RECEIPT DATE: 6-24-16 **ONSITE SEWAGE DISPOSAL SYSTEM** P 5580763

PROPERTY ADDRESS: 11017 Blevins Drive

Re: Blevins Property
Lot 3
Pump Design

SITE PLAN FOR BAT INSTALLATION
 BLEVINS PROPERTY
 LOT 3

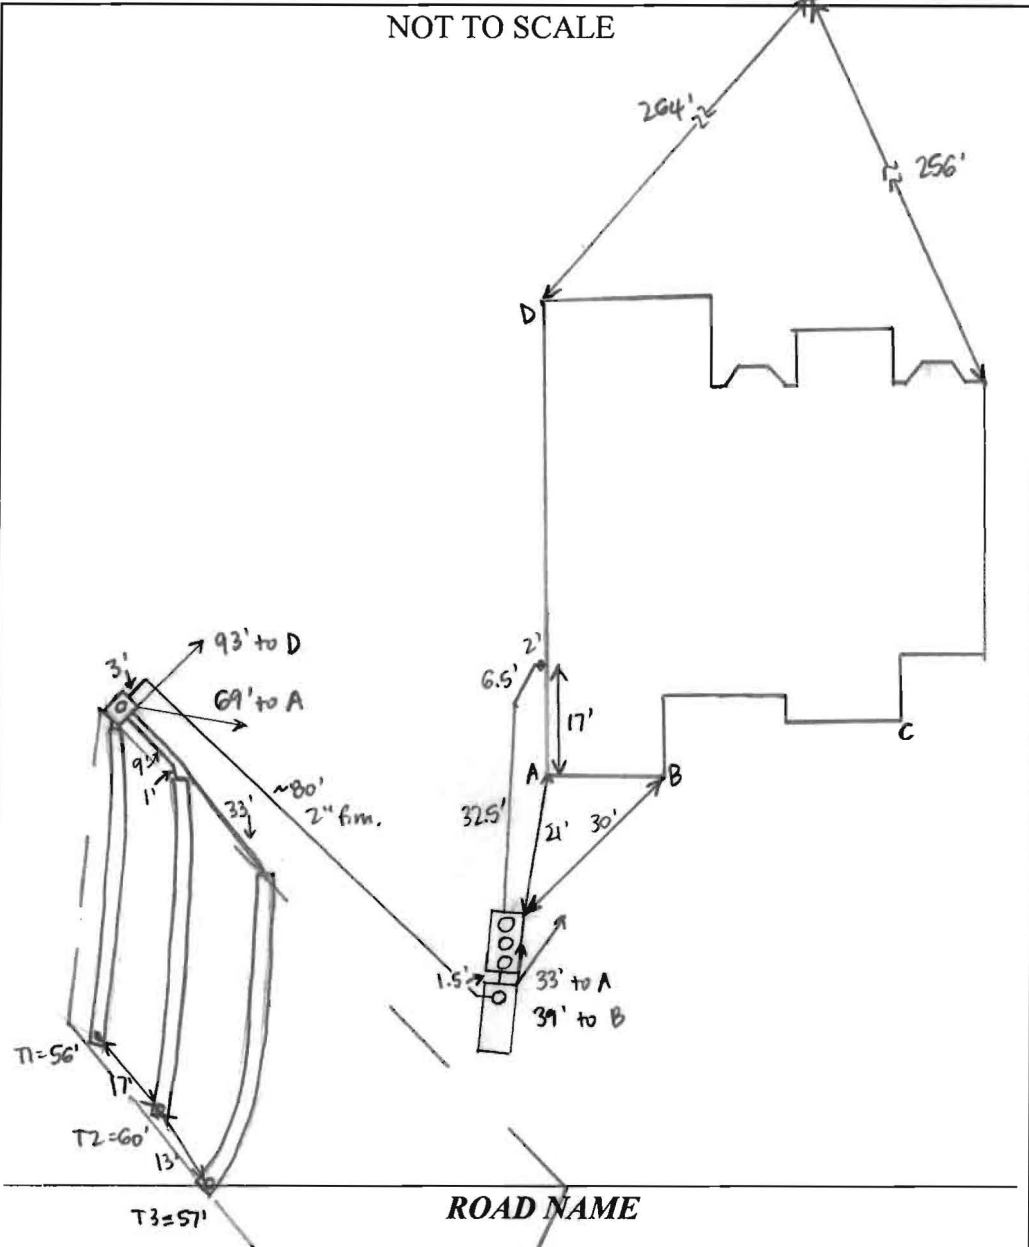
TRENCHES:	LINEAR FEET REQUIRED: <u>130' 69'</u>	INLET DEPTH: <u>4</u>
	TRENCH WIDTH: <u>32'</u>	MAXIMUM BOTTOM DEPTH: <u>8</u>
	MINIMUM SPACE BETWEEN TRENCHES: <u>12' 10'</u>	EFFECTIVE AREA BEGINNING DEPTH: <u>4</u>

NOTES: Install 3x56' trenches.

PRE-CONSTRUCTION:
 6/27/16 Met Hatfield's on site for layout. SDA and tank stakes present. Laid out 3 x 56' trenches on contour. (SC)

INSTALLATION: 6/28/16 Tanks set and house connection made. Some water at bottom of pump tank hole - Hatfield's says it's from the gravel bed under the foundation. (SC)
 6/29/16 T2 + T3 dug + left open at ends 3-3.5' to store + 2' wide. Hatfield's digging T1 during site visit, using laser to check bottom depth. (SC) 6/30/16 T1 complete. Need BAT startup certification and pump + alarm test. (SC) 7/5/16 BAT startup certification received. (SC) 9/1/16 No electrical powered to the unit. Contractor to reschedule (time) 9/10/2016 Pump and alarm working. (BB)

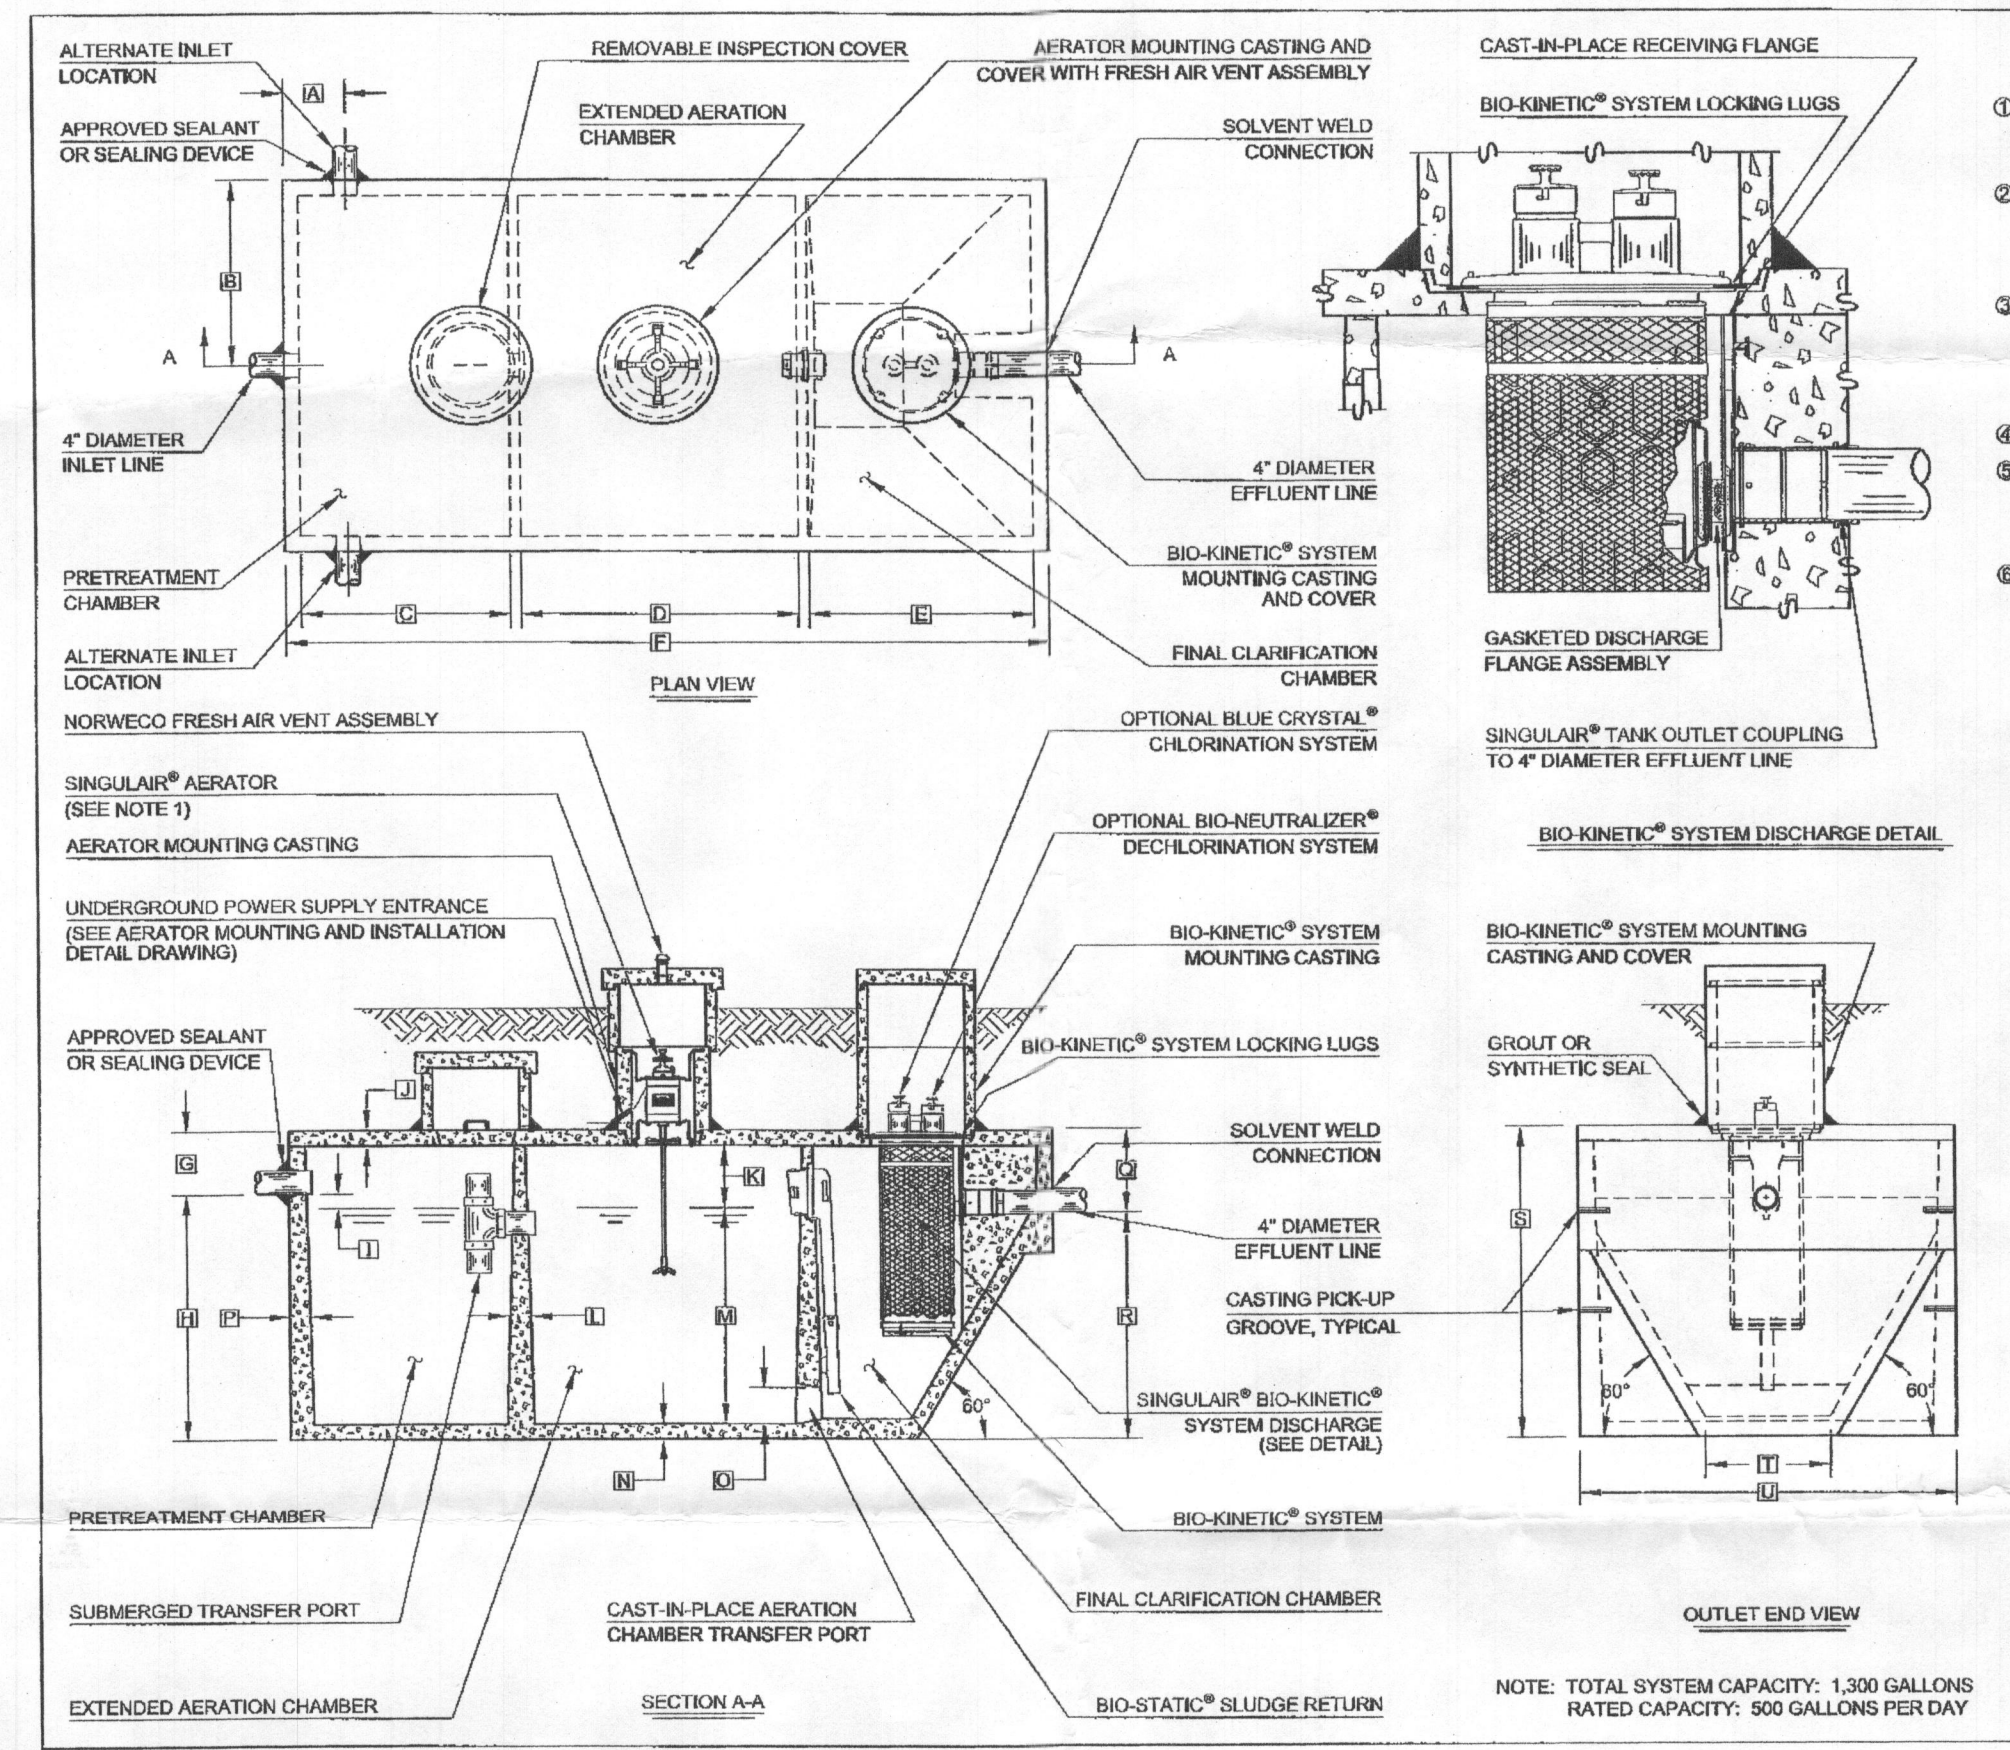
Approved Septic System Plan
 Howard County Health Department
 NORWECO TMTLP-500
 w/ Sewer 1500-gal Pump Tank
 & Myers SRM4 pump
 J. Buckles
 Signature
 2/31/15
 Date
